E3611A-07B-S N O T E

E3611A Manual DC Power Supply

POSSIBLE SHOCK HAZARD

LOOSE AC MODULE

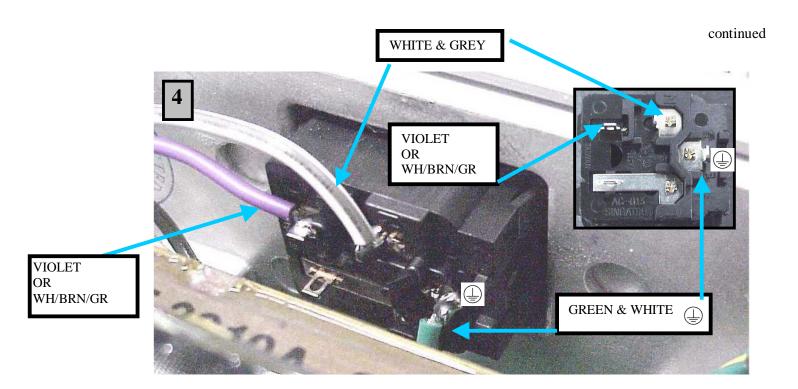
If the AC line cord is forcefully pulled in a side-to-side direction the AC Module can be pulled out of the rear heatsink, exposing the conductors that carry AC line voltage.

- 1. Make sure linecord is removed from outlet.
- 2. With linecord securely inserted in AC Module as shown, pull forcibly (2 times) in direction of arrow.

- 1. If AC Module pulls out from Unit as shown it will need to be replaced.
- 2. If AC Module remains in place it does not need to be changed. Put a mark on the AC input label in the lower left hand corner with indelible ink to indicate that the AC module has been checked. This label can be found below the AC module.

REMOVE COVER by prying Rear Bezel and Front Panel away from Cover in four places as shown. Then lift Cover off unit.

REPLACE MODULE with P/N 5065-6978. Before soldering perform "TEST FOR LOOSE AC MODULE" as shown in picture above. This will confirm that the new Module is secure. Solder wires and **REPLACE FUSE**.

100/120 VAC input use Fuse P/N 2110-0702 (2 amp, 250 volt) 230 VAC input use Fuse P/N 2110-0599 (1 amp, 250 volt)

CAUTION: WIRING MUST BE CORRECT OR HEATSINK COULD BE AT LINE POTENTIAL.

After AC Module is soldered, replace cover and turn unit on. No calibration or specification verification is required.
